FLD2026-05010
RESPONSES TO LETTER OF INCOMPLETENESS

Project Description and Address:

Carlouel Beach and Yacht Club
1091 Eldorado Avenue
Clearwater, FL

Applicant has reviewed the comments provided by the Development Review Committee (“DRC”) and has responded to each comment below in blue. As part of this re-submittal, Applicant’s design and development team has incorporated each department’s comments into the revised plans and responses which include:

SITE PLAN						
SAVE DATE		2/27/2026				
DRAWN BY		DES				
CHECKED BY		BAB				
PROJECT #		EP2025.02244				
FILE NAME		004-CYC_SITE				
SHEET NUMBER		06

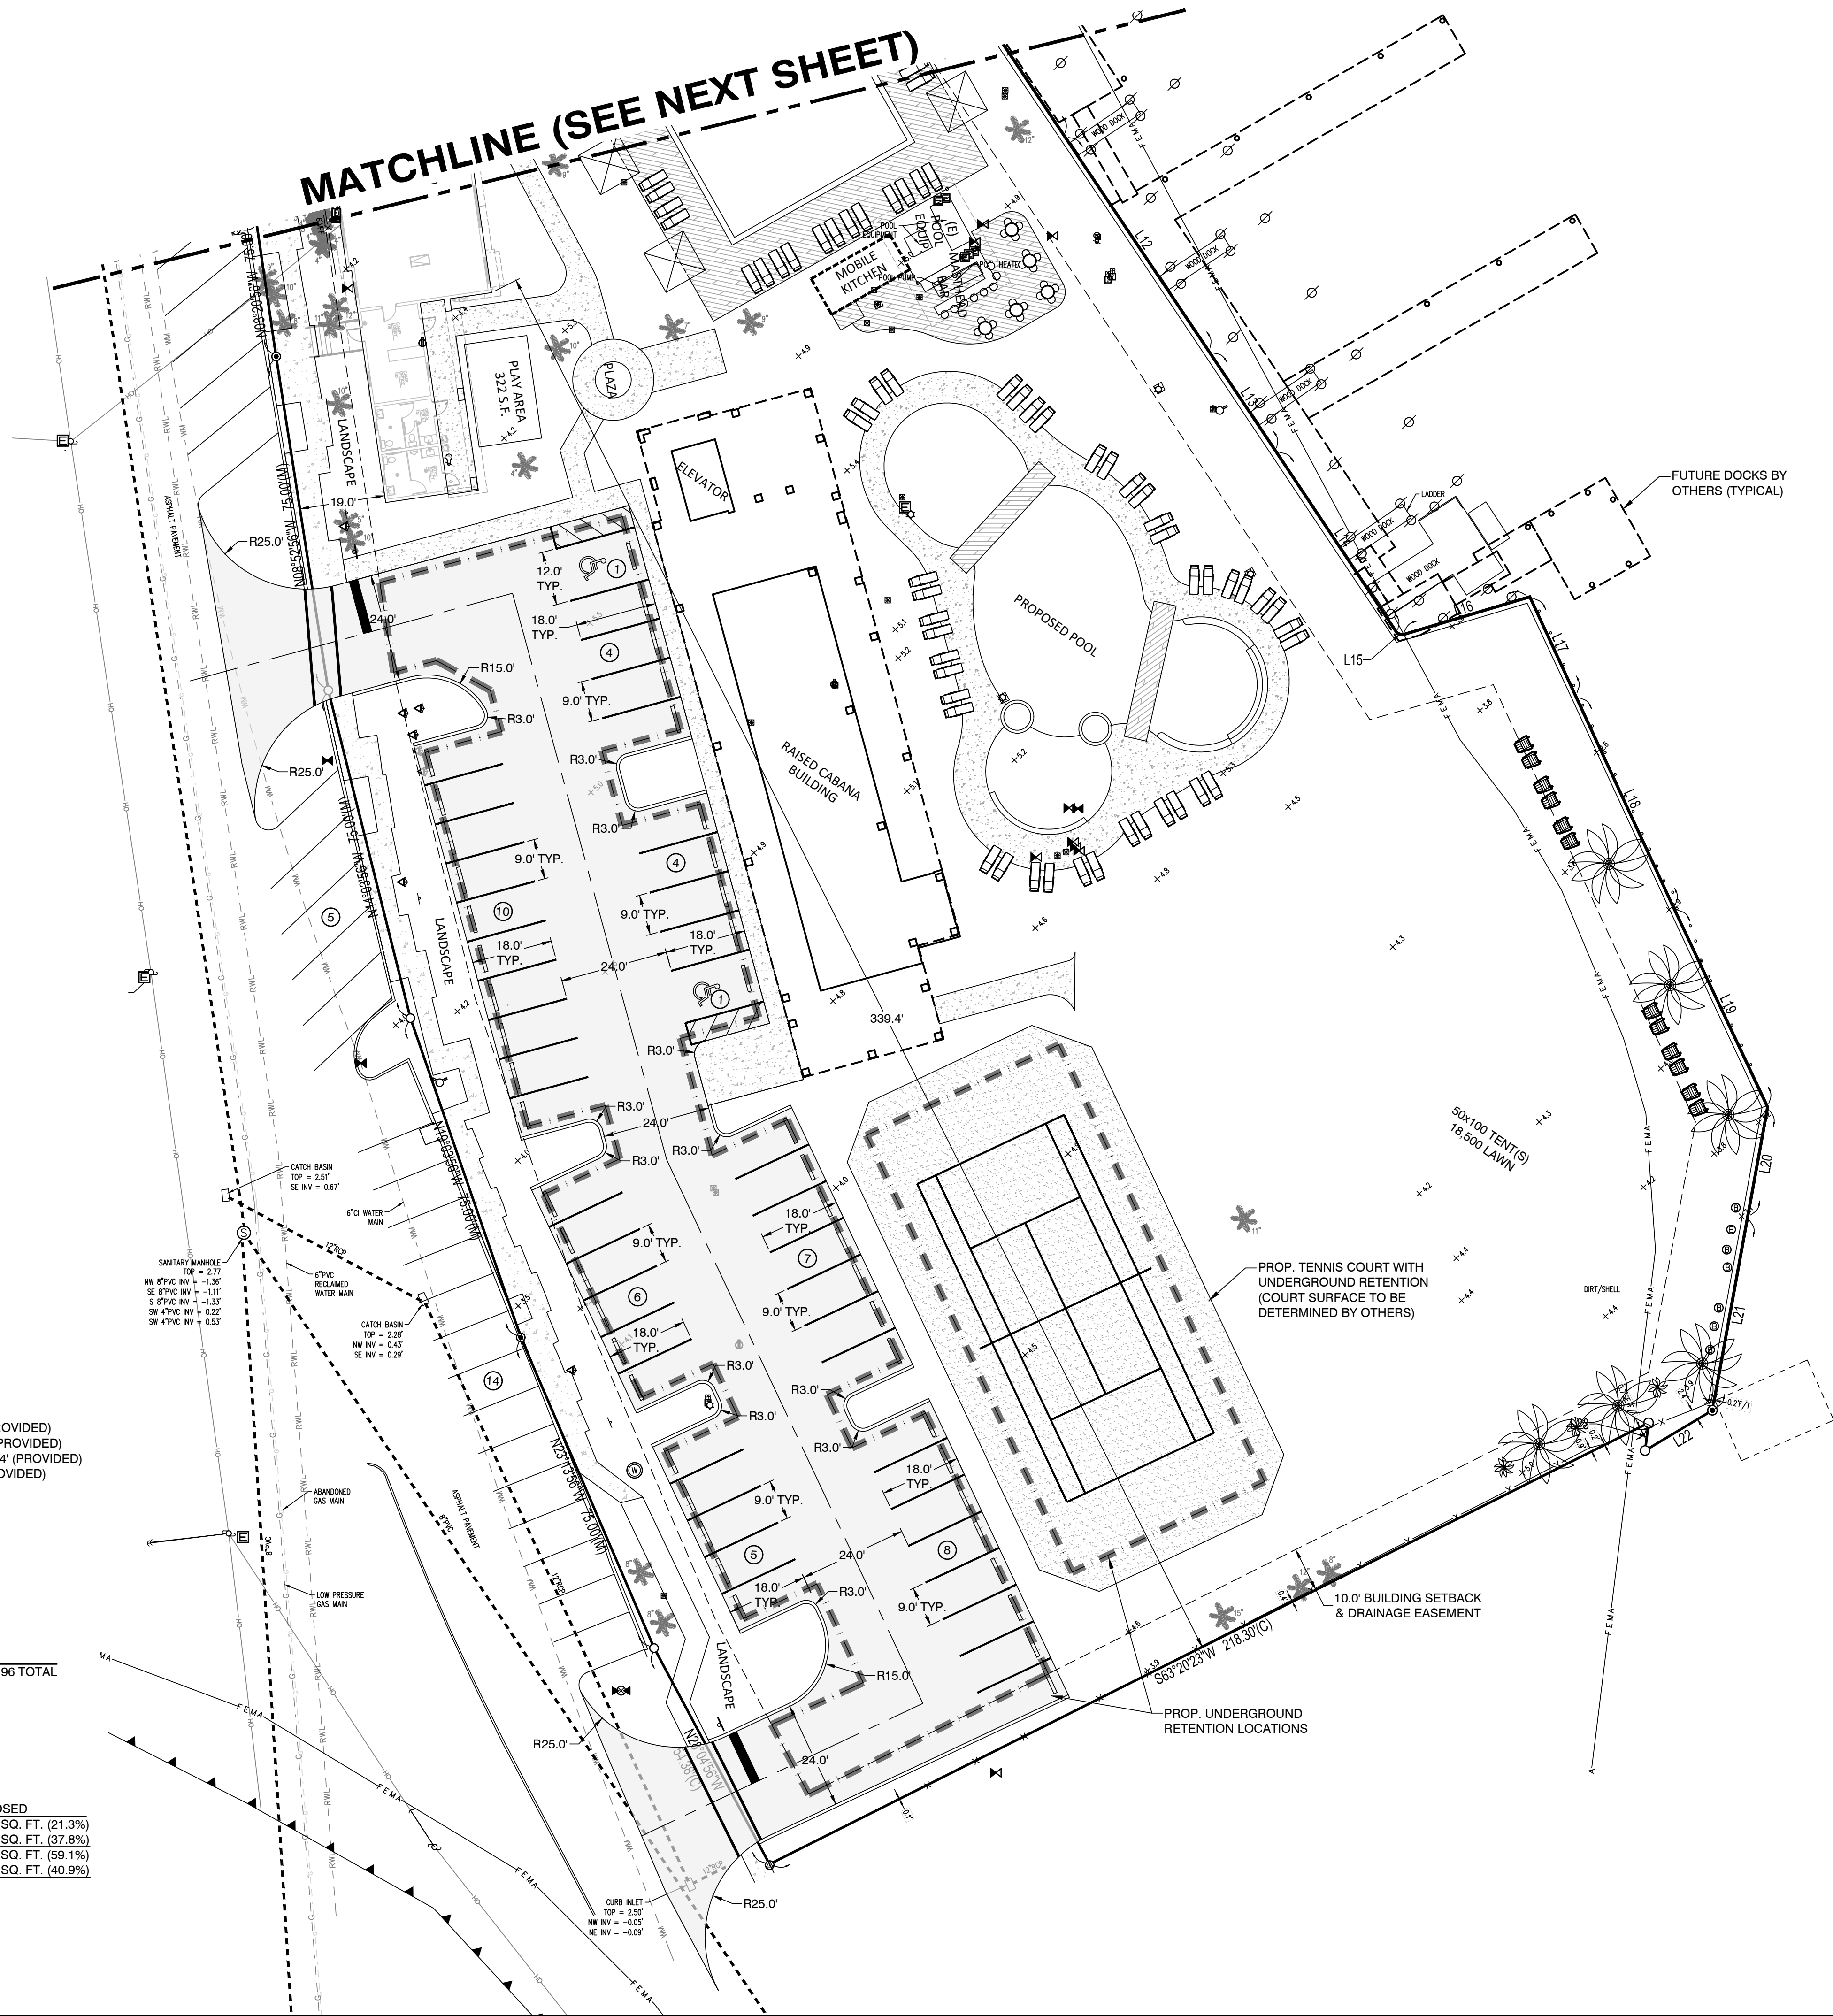
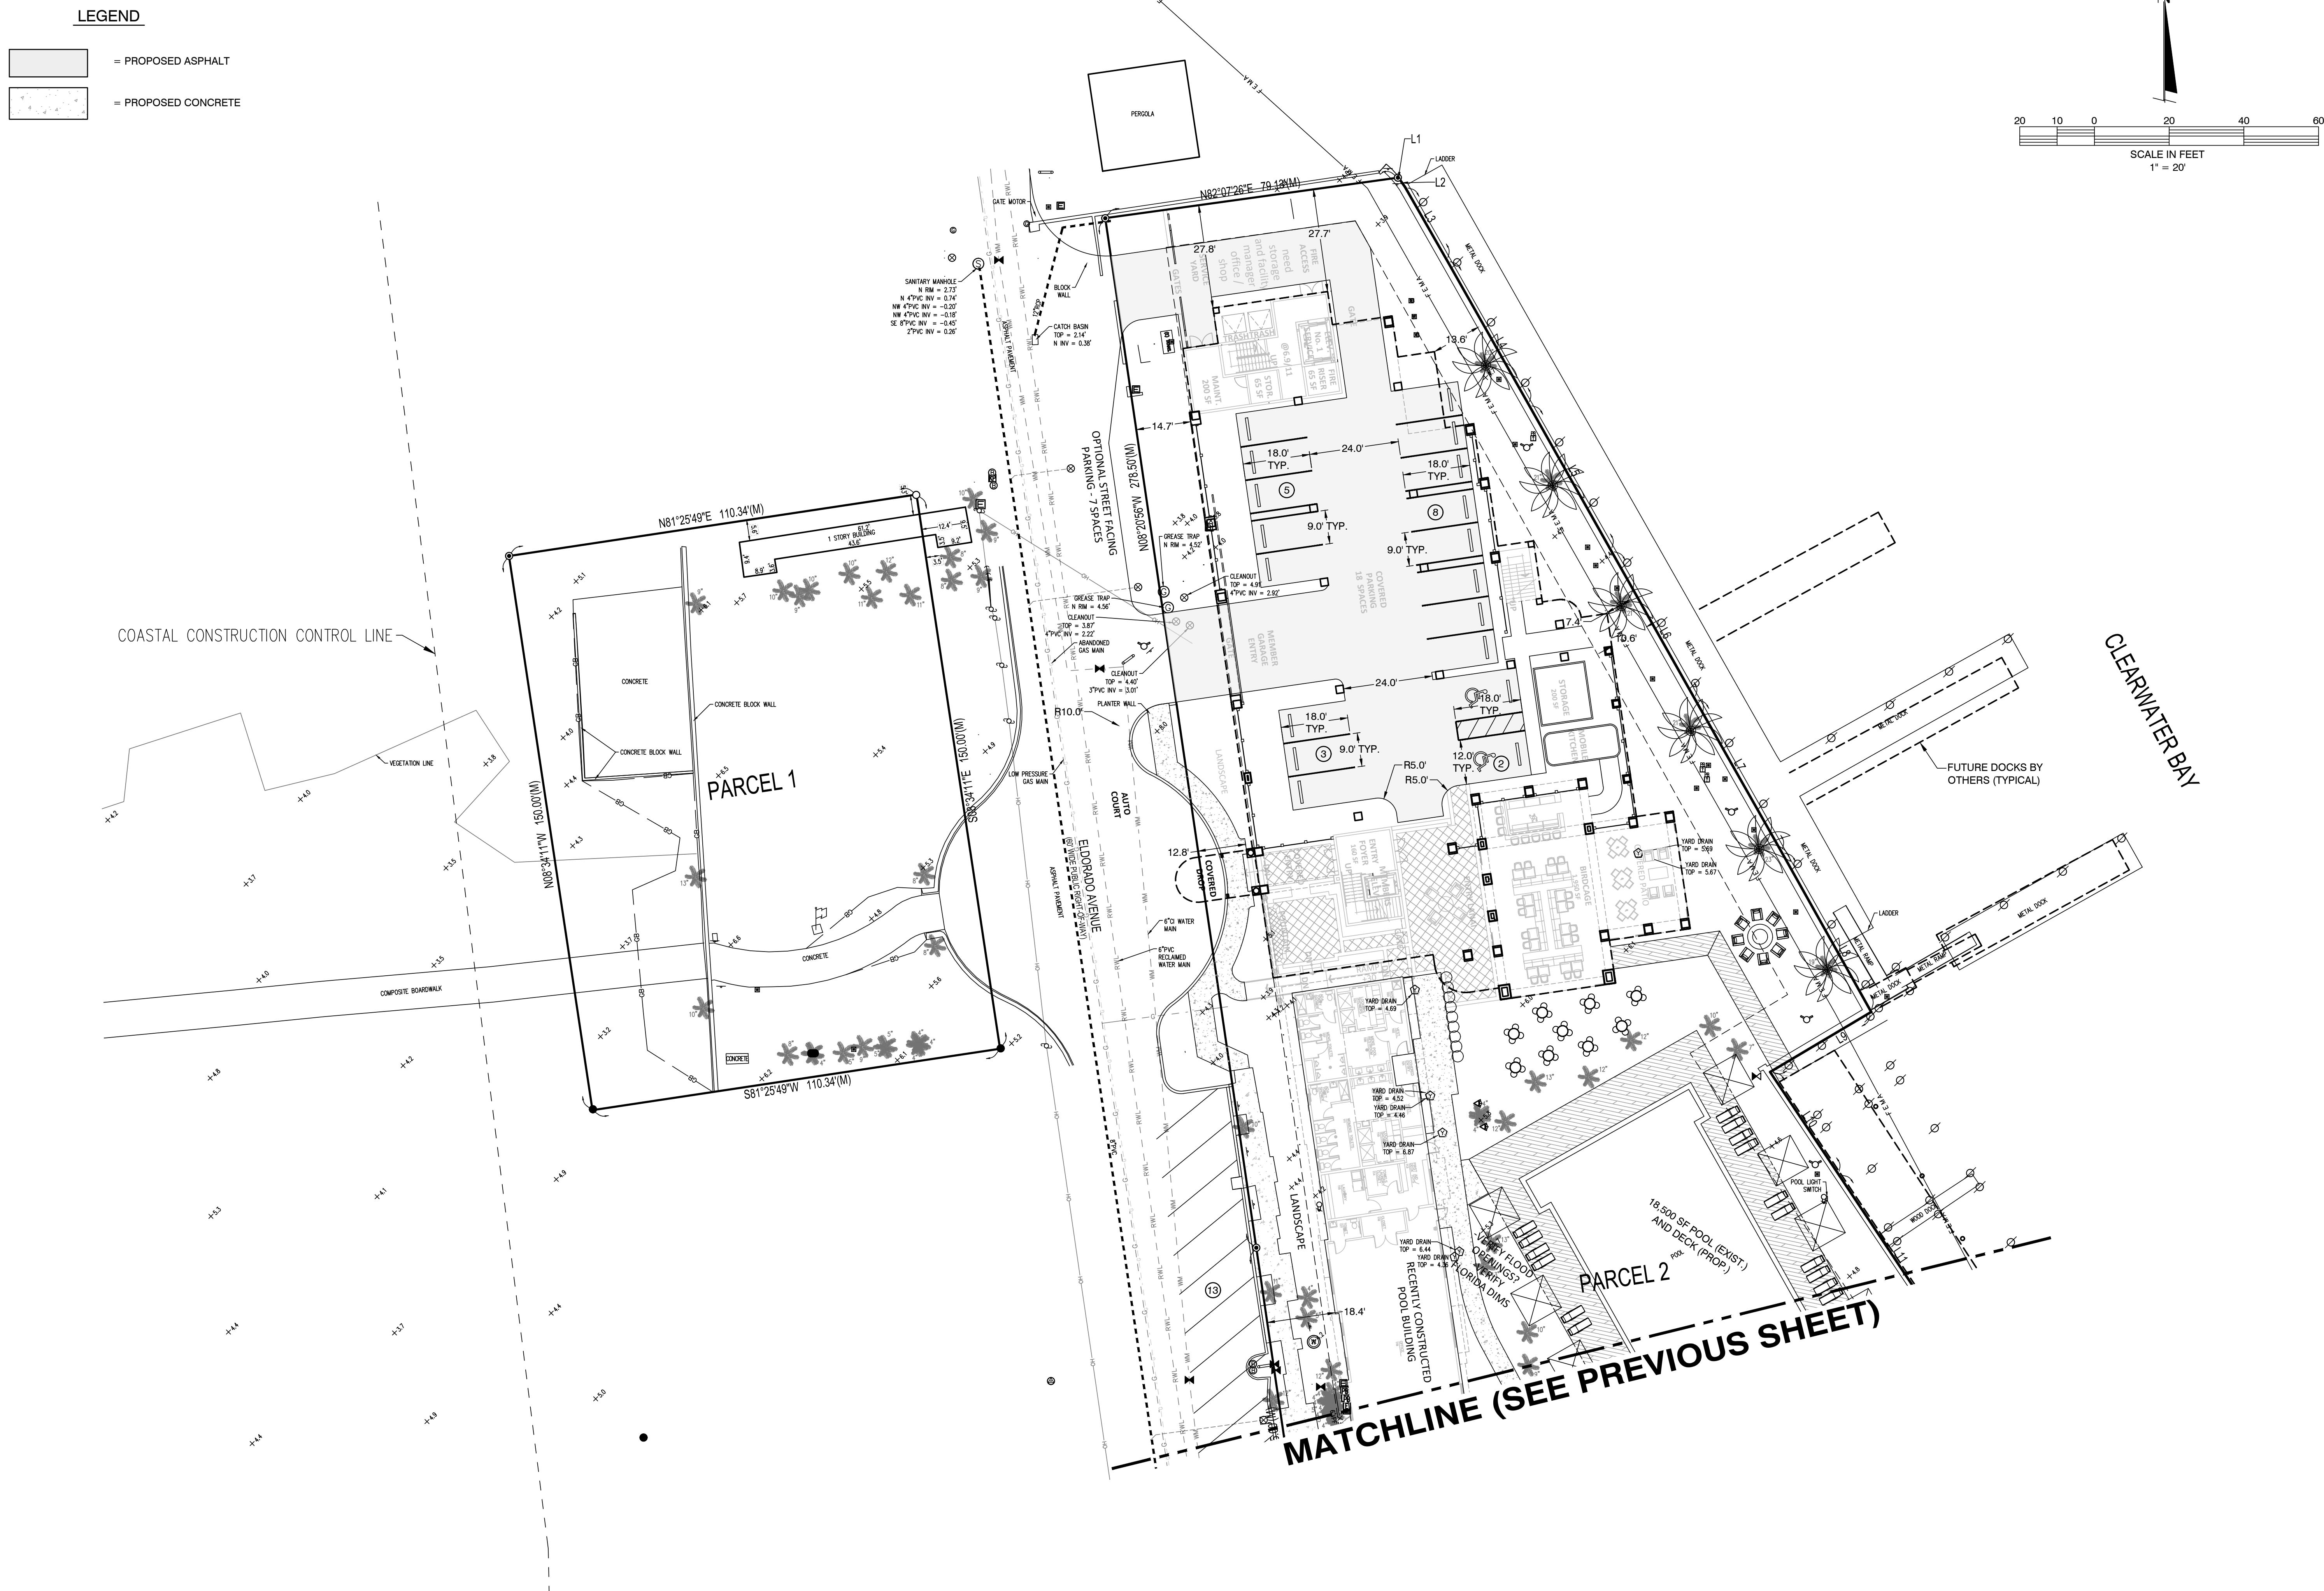
5. Provide a parking demand study. Per the site plan (Sheet 07) 133 parking spaces are required where 62 off-street parking spaces are proposed on-site. If flexibility of the parking standards is requested that is greater than 50 percent of the top end of the range (excluding those standards where the difference between the top and bottom of the range is one parking space), then a parking demand study will need to be provided. Prior to the preparation of such study, the methodology shall be approved by the Community Development Coordinator and City Engineer, and in accordance with accepted traffic engineering principles. The findings of the study will be used in determining whether or not flexibility to the parking standards are approved.

- **See parking demand study provided as part of the re-submittal documents.**
6. Revise elevations to:
 - (a) show horizontal facade dimensions.
 - (b) correctly measure height the of the building on all elevations.Height is measured as the vertical distance from the existing grade to a point representing the midpoint of the peak and eave heights of the main roof structure of the roof of a building having a pitched roof. Where minimum floor elevations in flood prone areas have been established by law, the building height may be measured as though the required minimum floor elevations constitute existing grade. In summary, measure from the design flood elevation (DFE) to the midpoint of the roof. The full definition of building height can be found in CDC Section 8-102.
